**MATERIALS LICENSE
SUPPLEMENTARY SHEET**

License Number 41-25047-02

SUBJECT: RESPONSE TO TECHNICAL ASSISTANCE REQUEST FOR REVIEW OF
TENNESSEE VALLEY AUTHORITY REQUEST FOR TERMINATION OF BY-
PRODUCT LICENSE 41-25047-02

RADIOACTIVE MATERIALS REMAINING IN THE ENVIRONMENT
DUE TO THE GROUNDWATER TRACER EXPERIMENT
CONDUCTED AT COLUMBUS AIR FORCE BASE, COLUMBUS, MISSISSIPPI,
AND ESTIMATIONS OF THEIR DOSES TO THE PUBLIC,
BY-PRODUCT LICENSE 41-25047-02

Figure 5. Observed Tritium Concentration Histories for Selected Sampling Points Located In Last Row of Monitoring Network

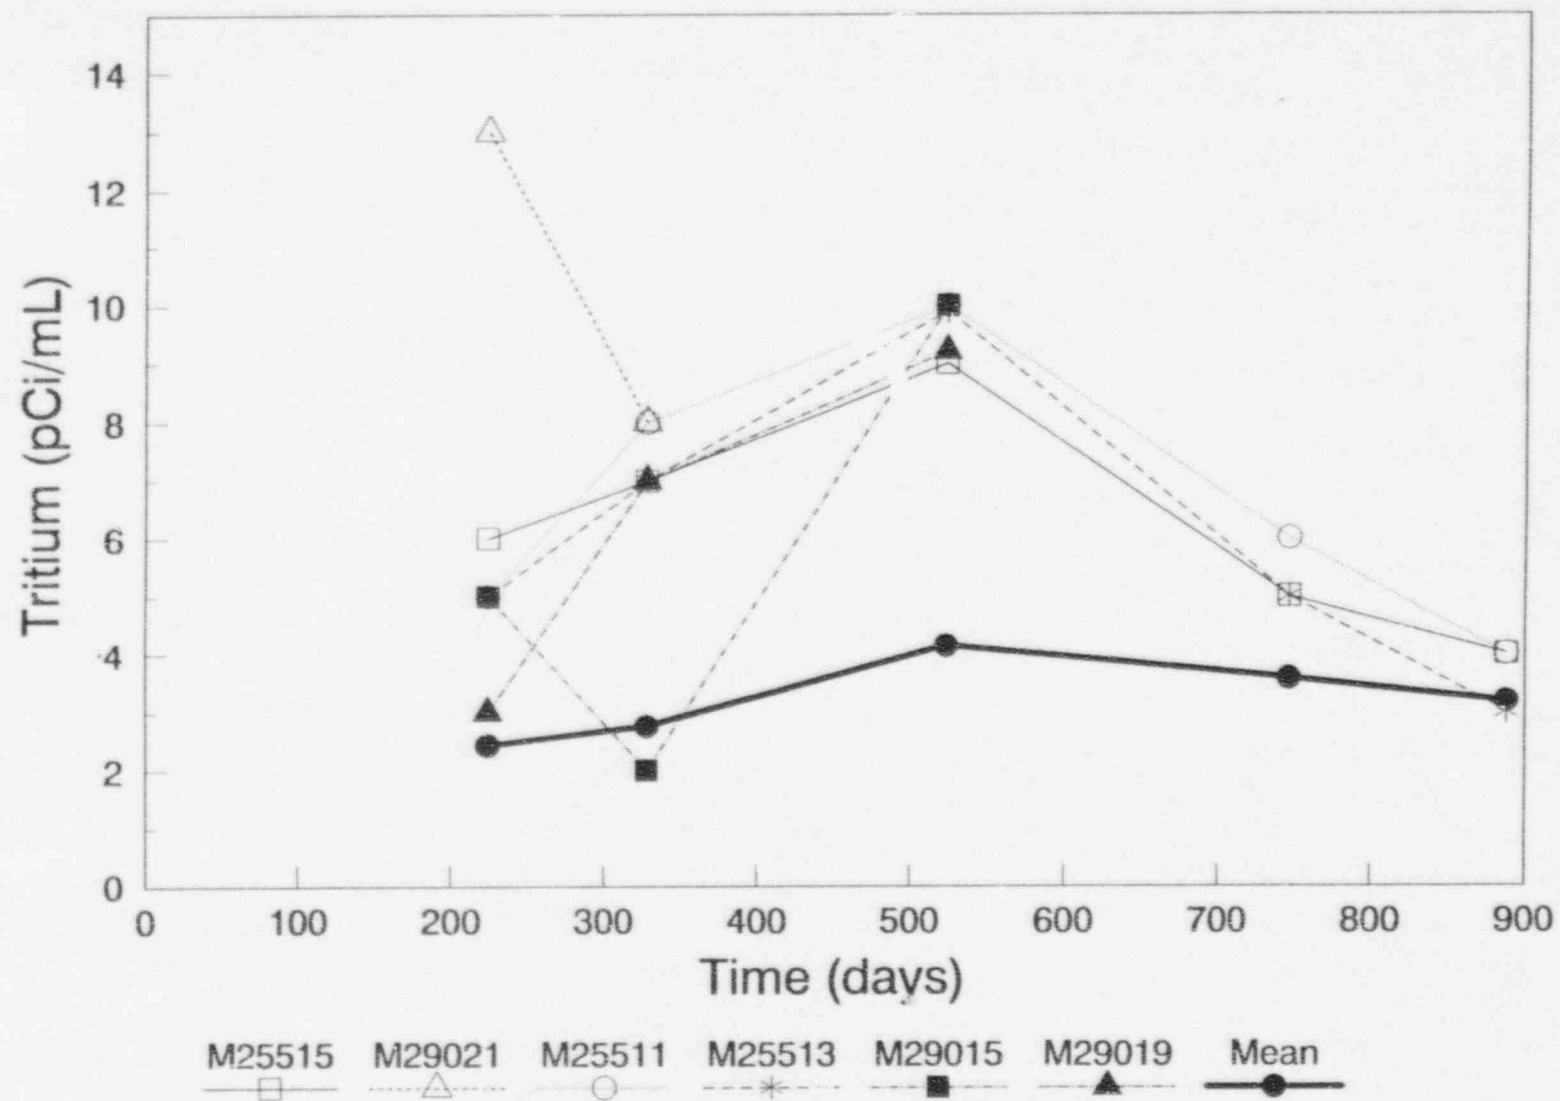
Second, figure 5 of enclosure 3 to form 314 of the March 27, 1996 letter was omitted. It is enclosed with this memorandum.

Figure 8. Predicted Tritium Concentrations at Receptors

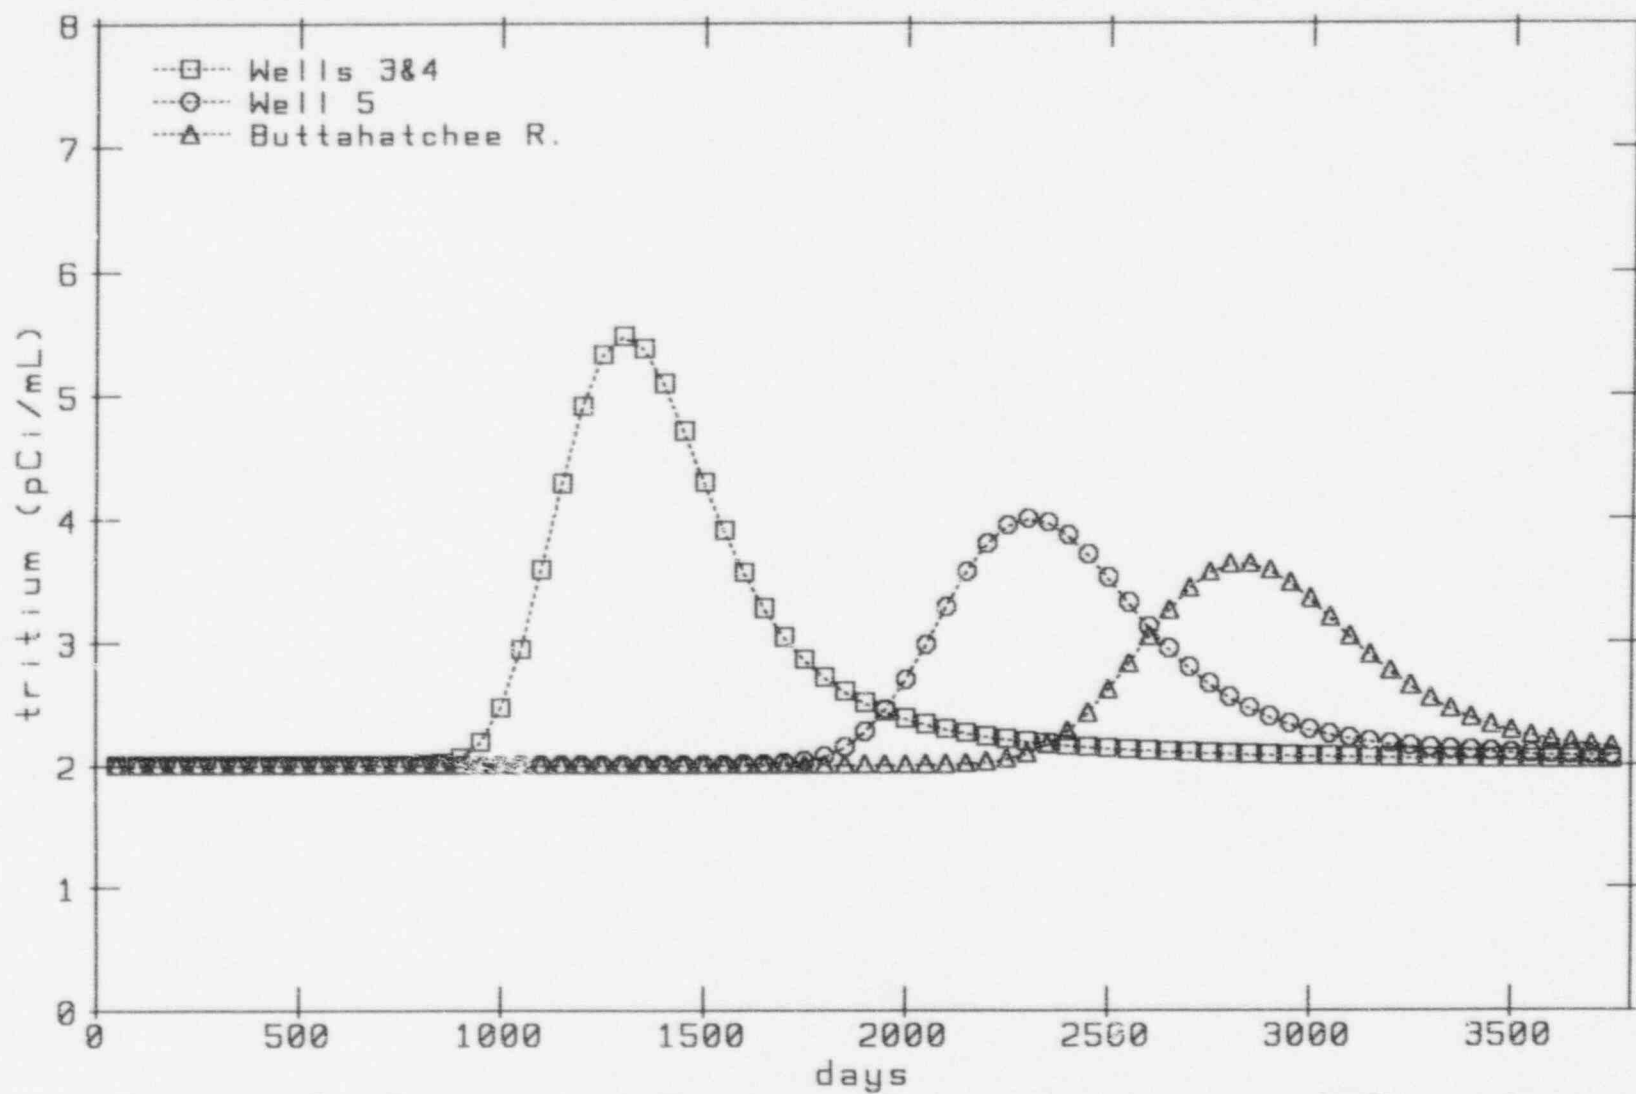
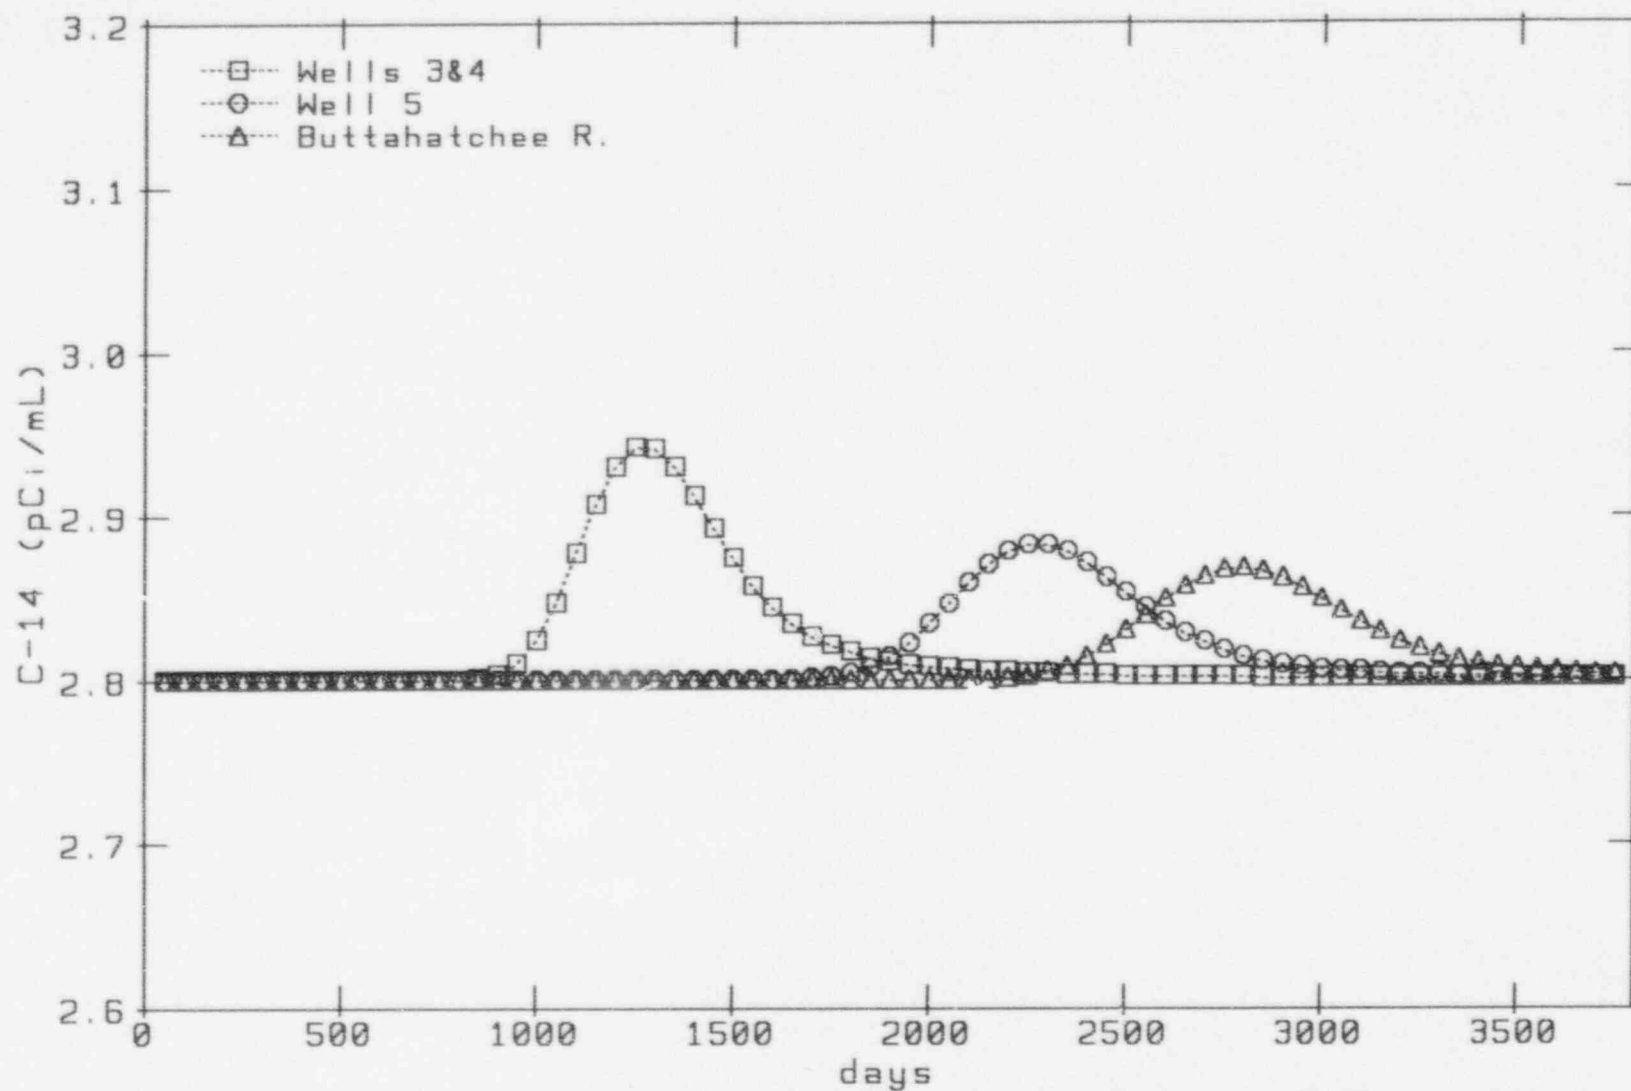
The maximum concentrations of H-3 and C-14 in ground water, based on monitoring and modeling predictions, are 4 and 0.2 pico Ci/ml, above background, see Figures 8 and 9 in enclosure 3.
